SAND CREEK RESTORATION

PCD PROJECT NUMBER: CDR-20-004 PUBLIC IMPROVEMENT CONSTRUCTION PLANS

ERD STORMWATER REVIEW COMMENTS
 IN ORANGE BOXES WITH BLACK TEXT

**SAND CREEK - BANKFULL PROFILE 5
STA 53+00.00 TO 70+00.00**

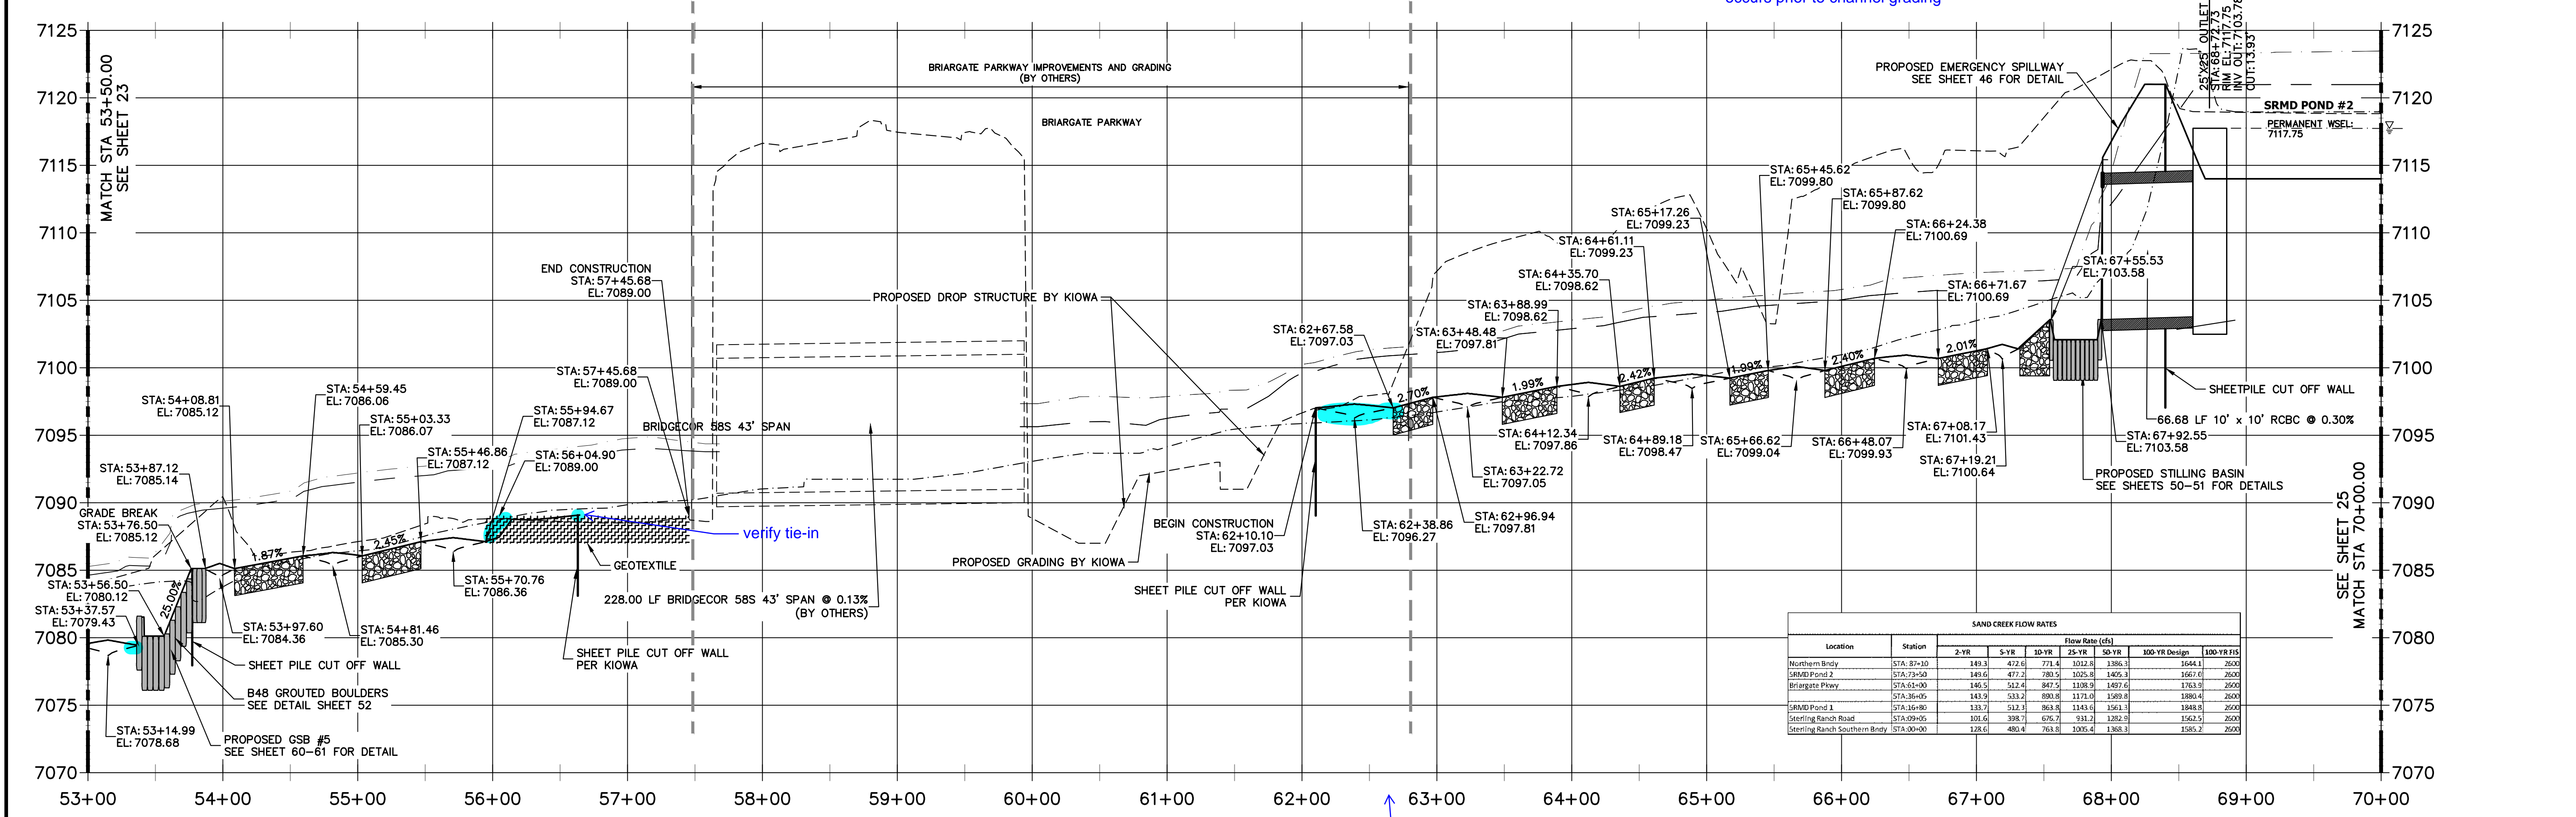
Add note that these areas will be graded with subdivision grading if it occurs prior to channel grading

Modeling indicates supercritical flows - verify stability. Response says soil riprap will be added.

GRouted STEPPED BOULDER DROP #2 DETAIL
PLAN VIEW
SCALE: 1"=20'

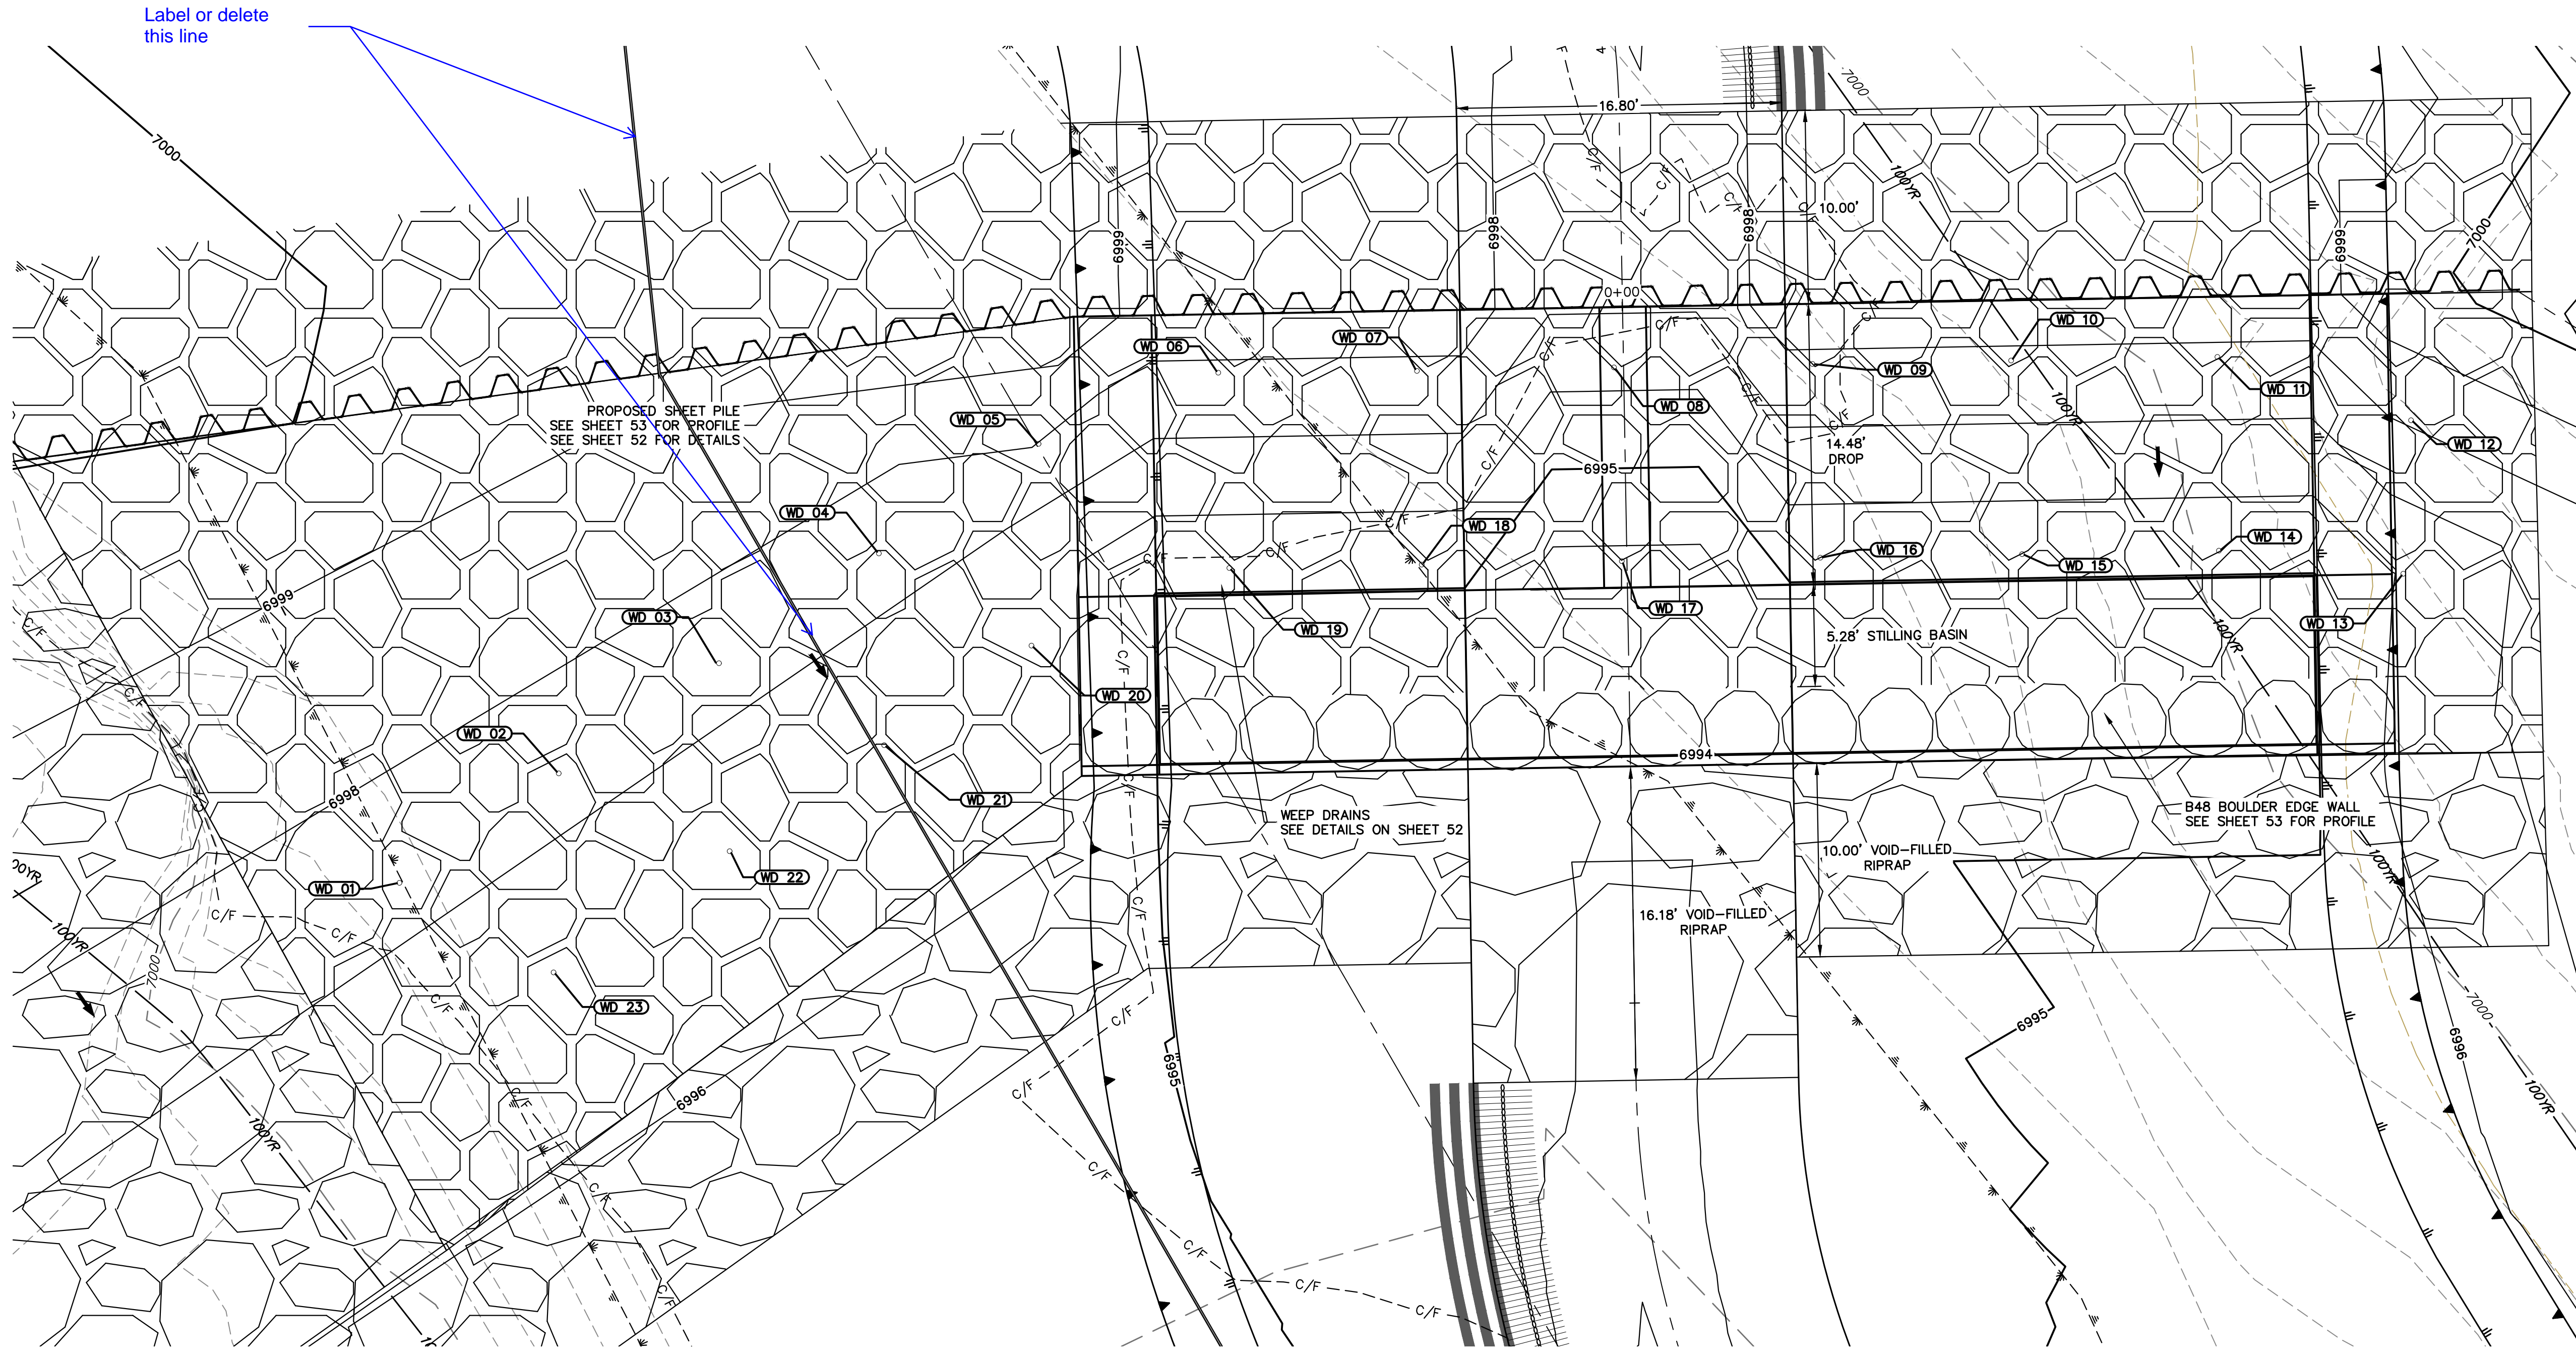
Show as existing grades?

GROUPED STEPPED BOULDER DROP #3 DETAIL
PLAN VIEW
SCALE: 1"=20'

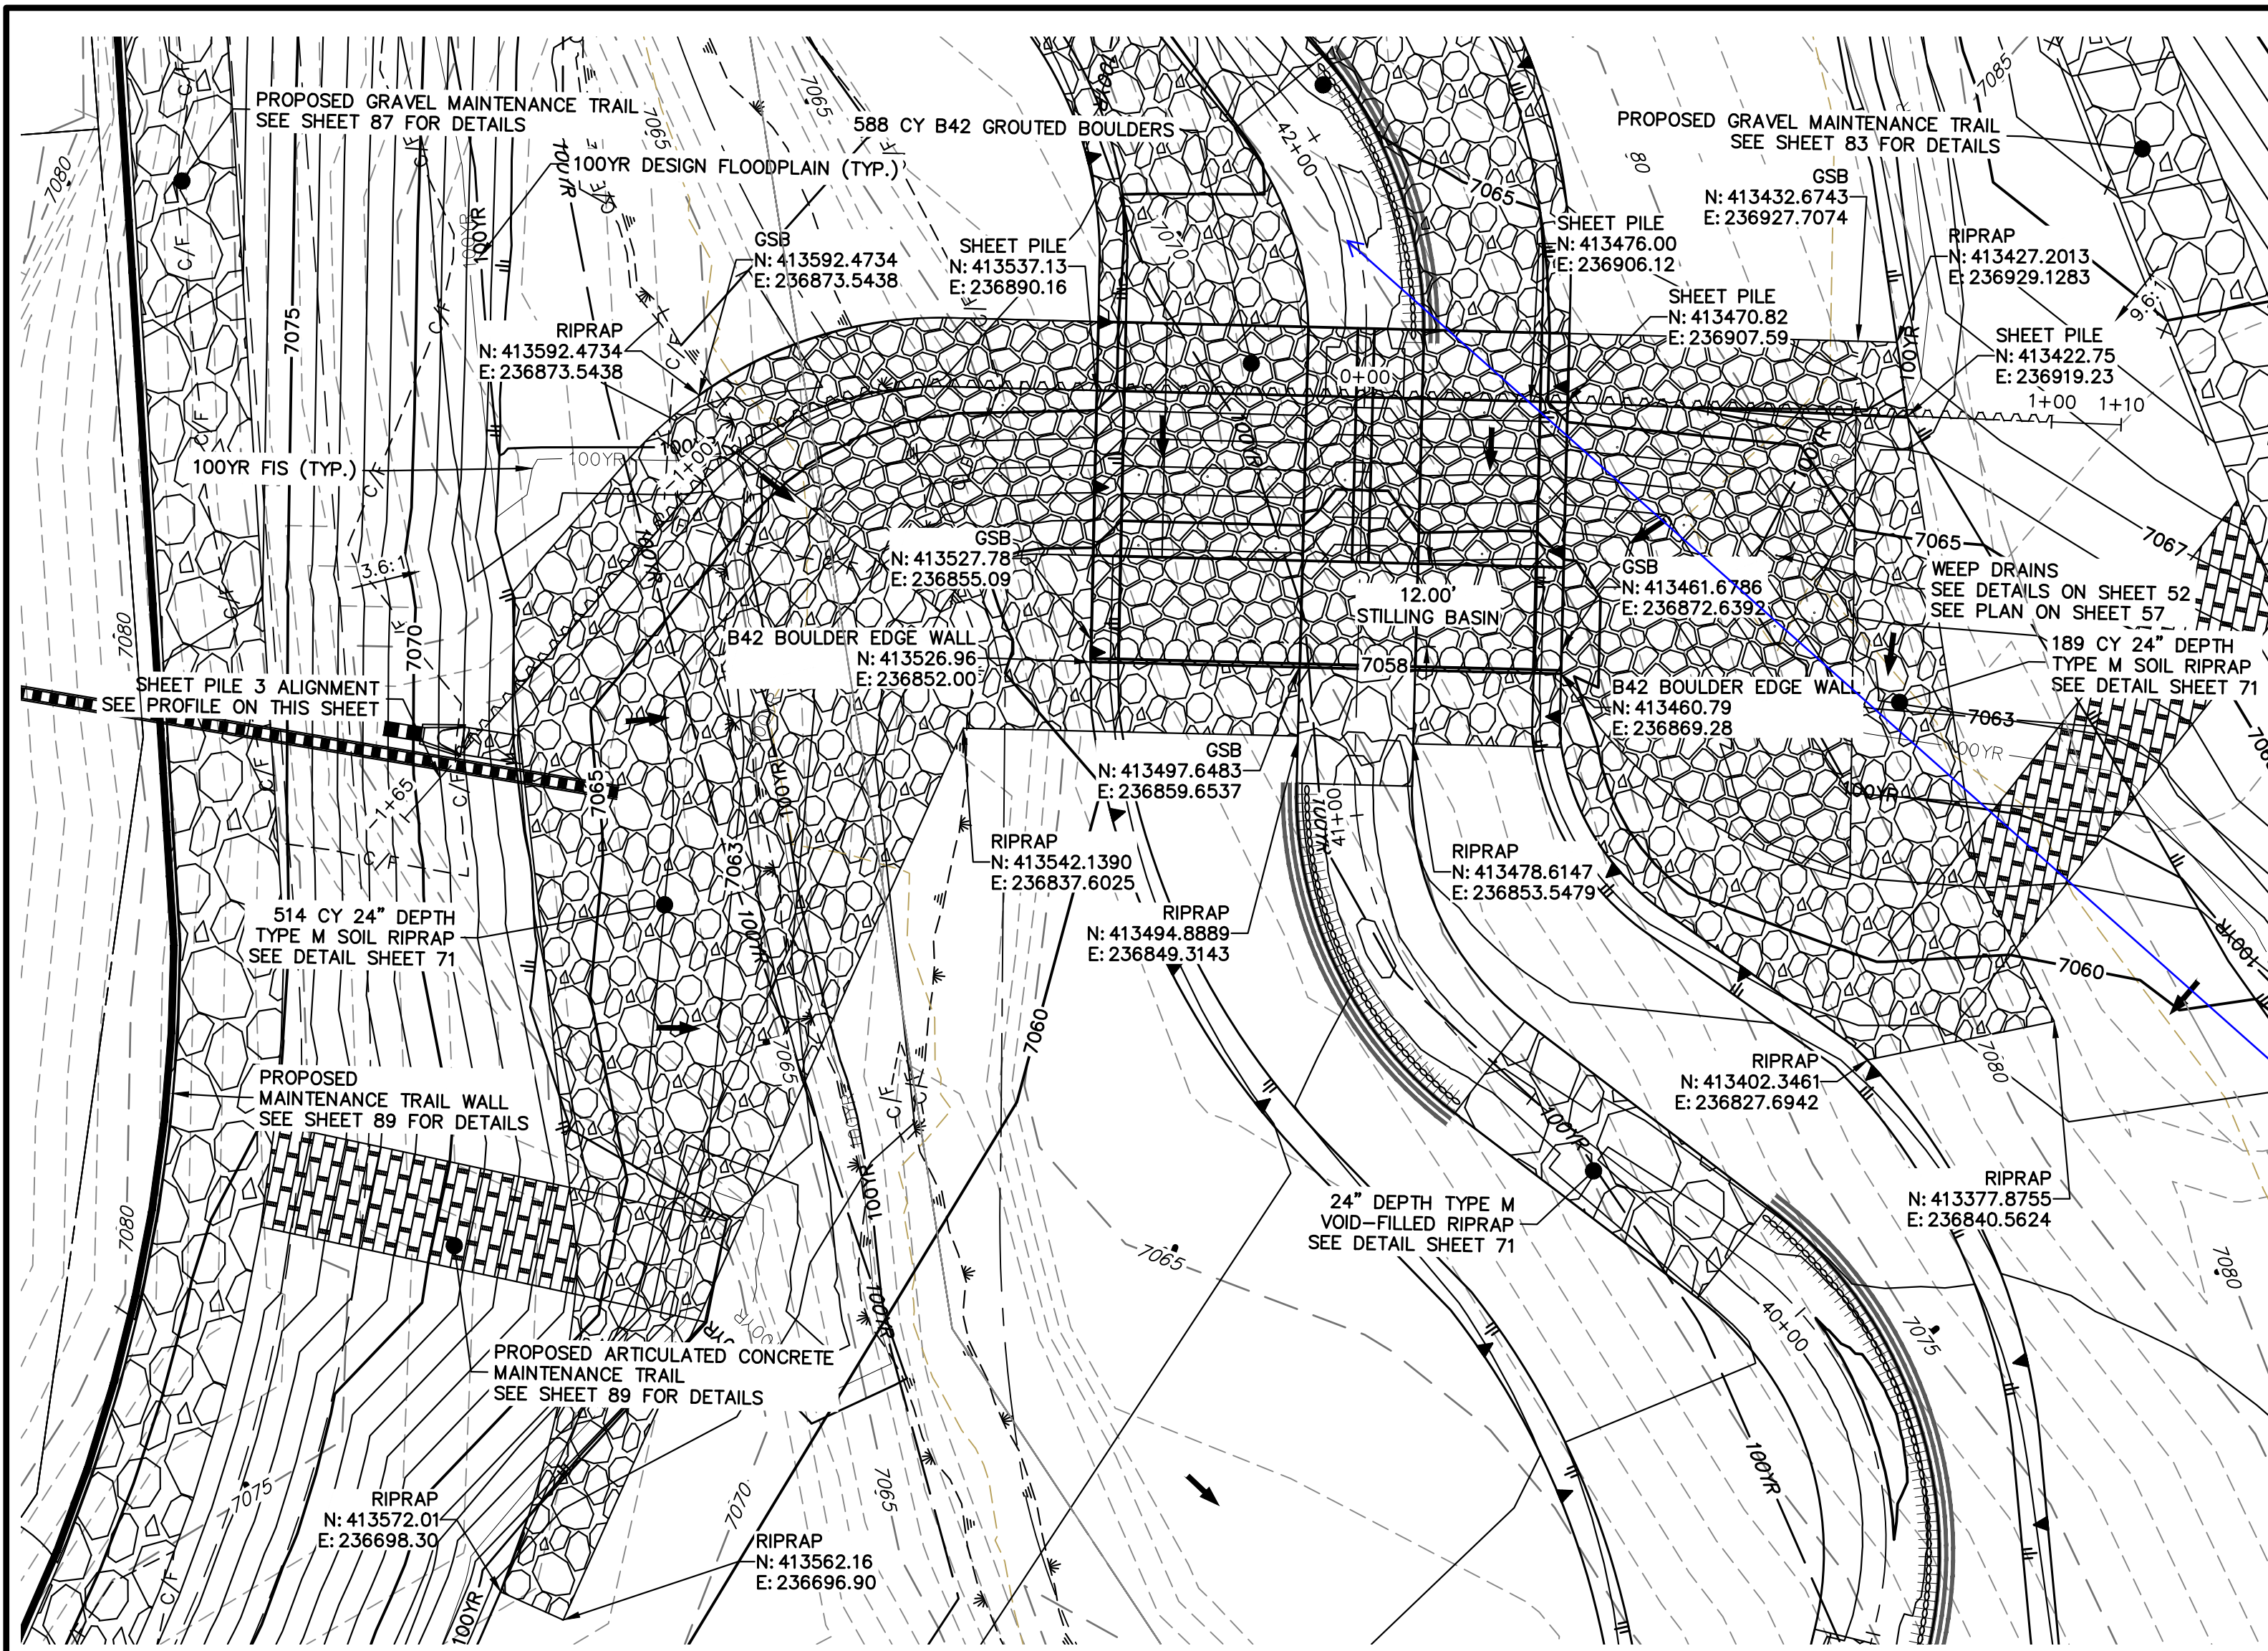
lining needed?
Response says
soil riprap will be
added.
